NOTICE TO ALL FIRMS

Re: Addendum Number 2
IFB # C1576 – D442 Classroom Renovation

PROJECT:
D442 CLASSROOM RENOVATION
POMERANTZ 300 7TH AVE
NEW YORK NY 10001

FOURTH FLOOR PART POWER PLAN

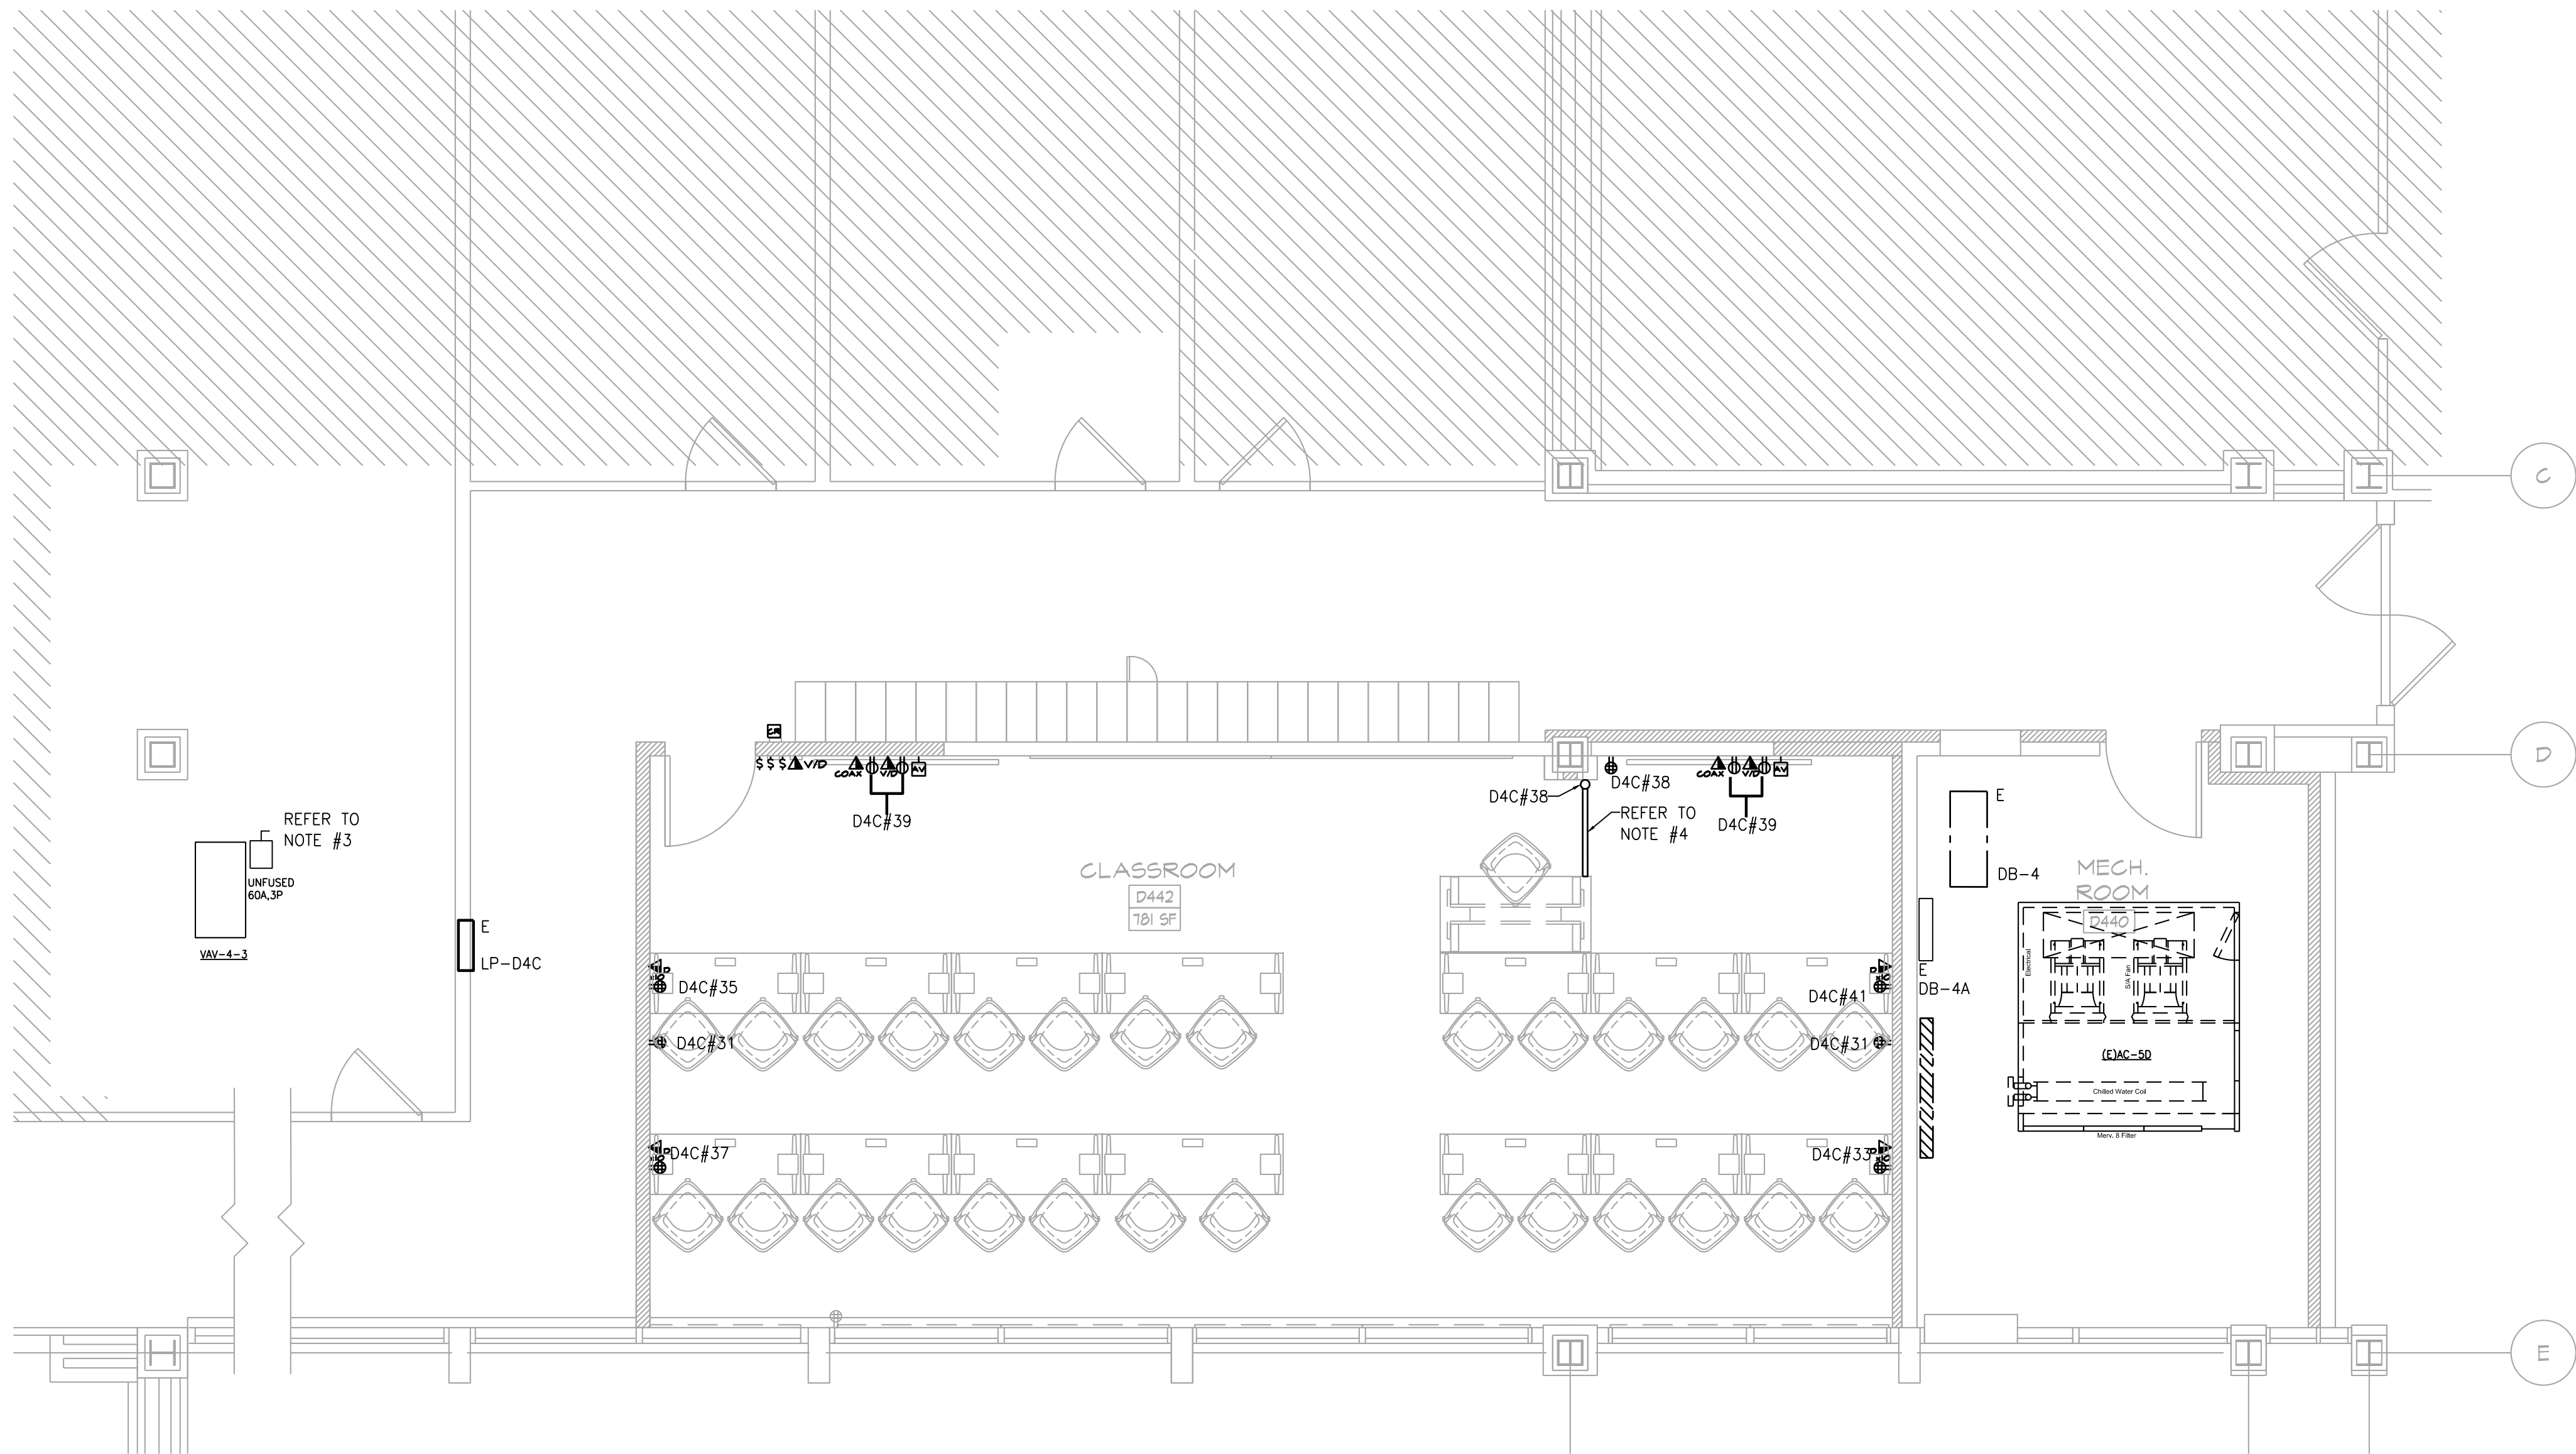
- Q3. Is the GC only required to provide back boxes and conduit stub ups for the data/comm/AV outlets?
- A3. Refer to Electrical drawings power notes on drawing E-200. FIT IT will pull the wiring. GC to coordinate with FIT's Data and AV contractor.
